REVISED RESPONSE TO REQUEST FOR ADDITIONAL INFORMATION**APR1400 Design Certification****Korea Electric Power Corporation / Korea Hydro & Nuclear Power Co., LTD****Docket No. 52-046**

RAI No.: 179-8190

Question No. 09.01.01-21Question 9.1.1-3: Design of new fuel storage rack system**REQUIREMENTS AND GUIDANCE**

Figure 2.4-2 Criticality Calculation Model for a Dropped Fuel Assembly Accident (Contact)

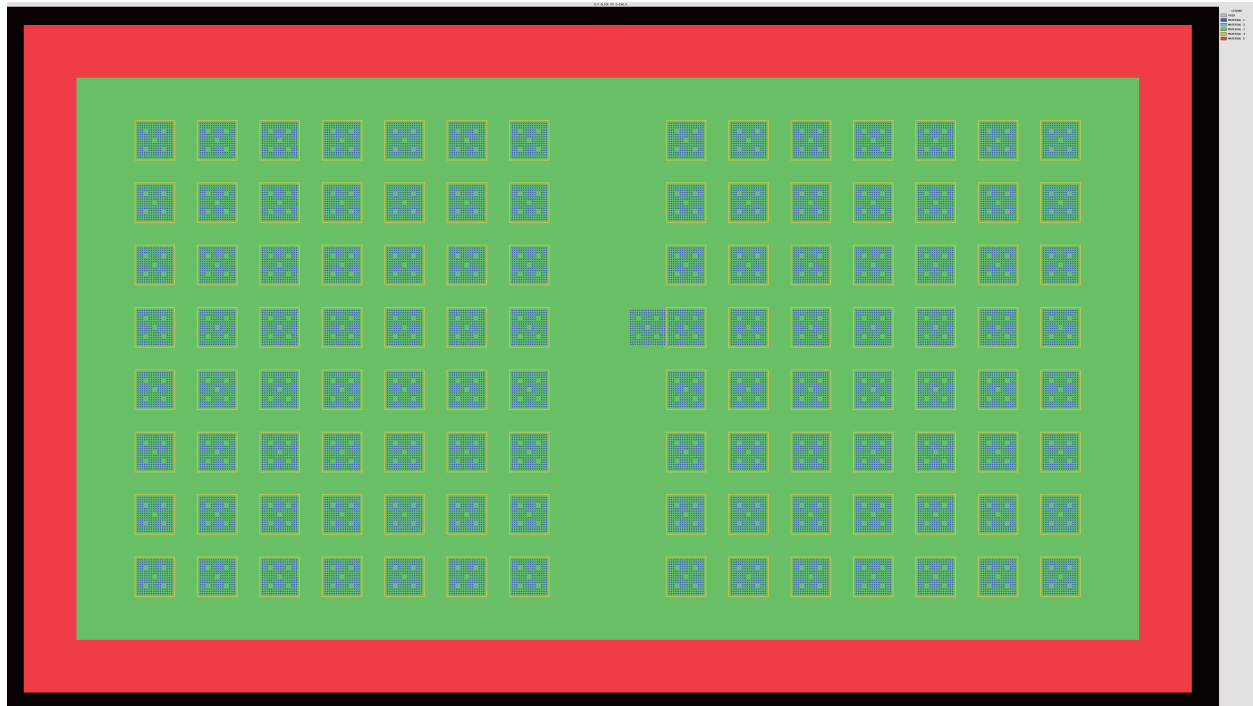
As described in DCD Section 9.1.1 and the criticality report, the design of the APR1400 new fuel storage pit appears to have spaces between the fuel racks and between the racks and pit walls that are large enough to fit one or more new fuel assemblies. The NRC staff is therefore not able to verify that the design is such that a fuel assembly can only be inserted in the designed locations in the new fuel racks and that construction will be such that it will not be possible to place fuel assemblies closer to one another than the minimum specified separation in the racks and any adjacent regions external to the racks.

The applicant should provide information showing that the design is such that a fuel assembly can only be inserted in the design locations in the new fuel racks or justify the acceptability of the current design where spaces between and around the racks that are large enough to fit one or more fuel assemblies. This should include information describing how the design is bounded by the accompanying criticality analysis report. Any revised or supplemental information addressing this issue should be provided in the applicant's response and reflected in the DCD or its incorporated references as appropriate.

There are spaces between the fuel racks and pit walls that are able to fit a new fuel assembly. An accident analysis, that assumes a fresh fuel assembly is dropped and positioned in the space between fuel racks in the new fuel rack storage pit, has been performed and will be added in the criticality analysis TeR.

For one of postulated accident conditions, a fresh fuel assembly is assumed to be dropped and positioned in the space between the fuel racks in dry air environment. The dropped fuel assembly accident evaluation considers the fully loaded NFR model with a dropped fresh 5.0 wt% fuel assembly between the fuel racks. Two sub-cases are considered. Subcase 1 is for a dropped fuel assembly face adjacent to the one of rack cells as its closest proximity and subcase 2 is for a dropped fuel assembly being centered in the space between the fuel racks. The criticality calculation models for a dropped fuel assembly cases are shown in Figures 2.4-2 and 2.4-3.
